Project: VBB 740.003

Subject: Work plan

Work Plan
Groundwater Contamination Assessment
1345-1375 Grand Avenue
Piedmont, California

SITE PLAN			PLATE 1
1345-1375 GRAND AVENUE - PIEDMONT, CA			
JOB NUMBER 740.003	DATE 2/3/85	APPROVED <i>TZ</i>

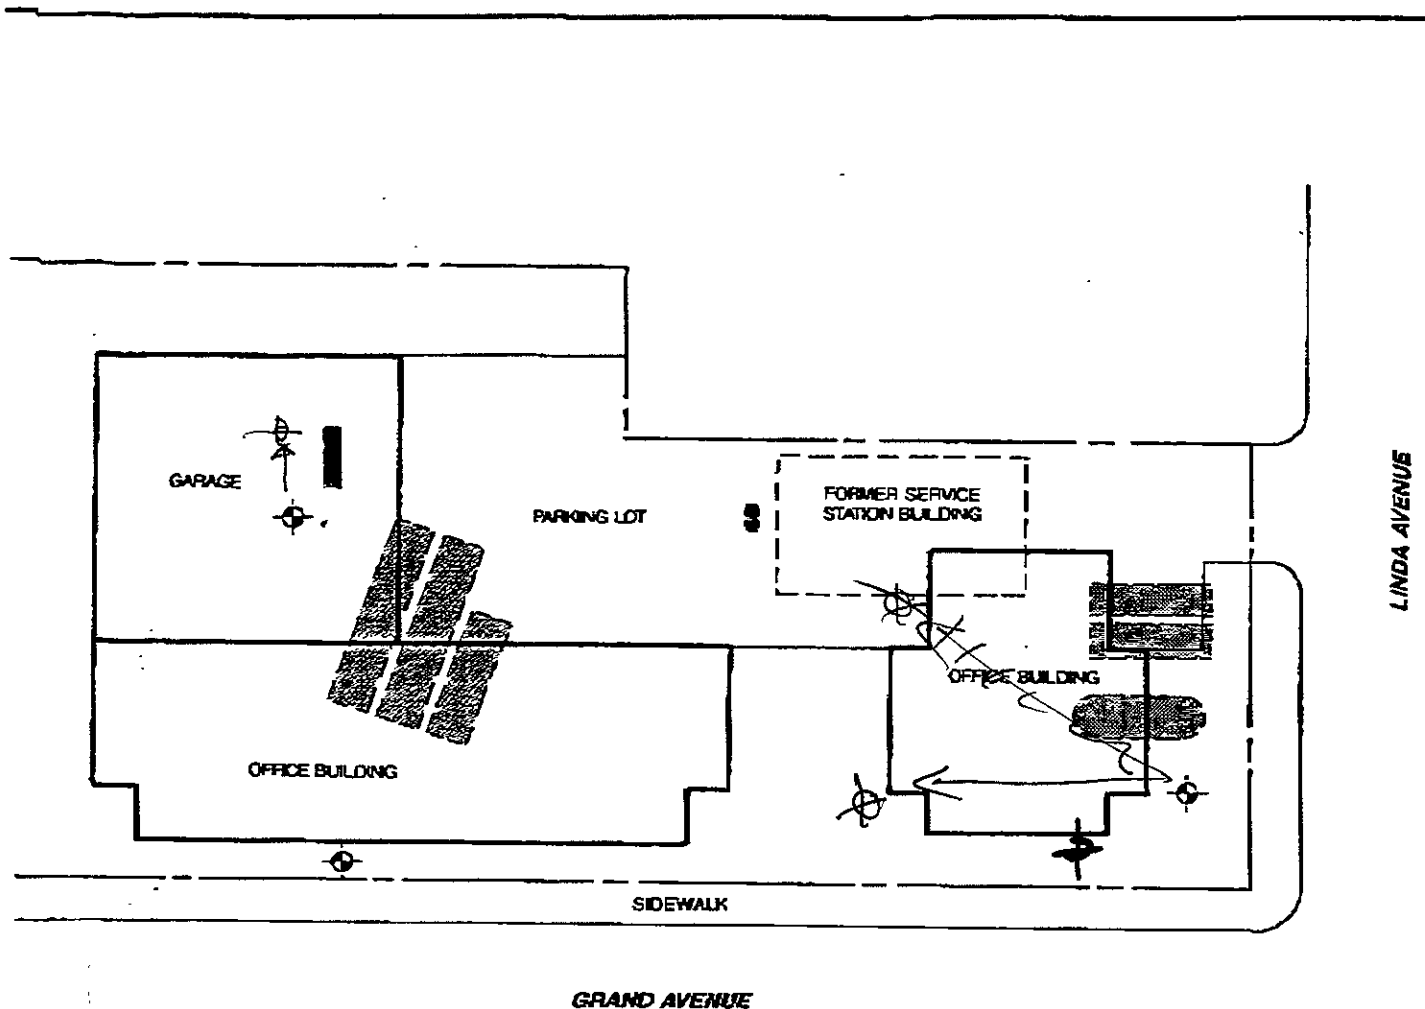
*see if there are rights nearby
for GW flow direction*

*per Tom Echols, it is believed GW
flow to south*
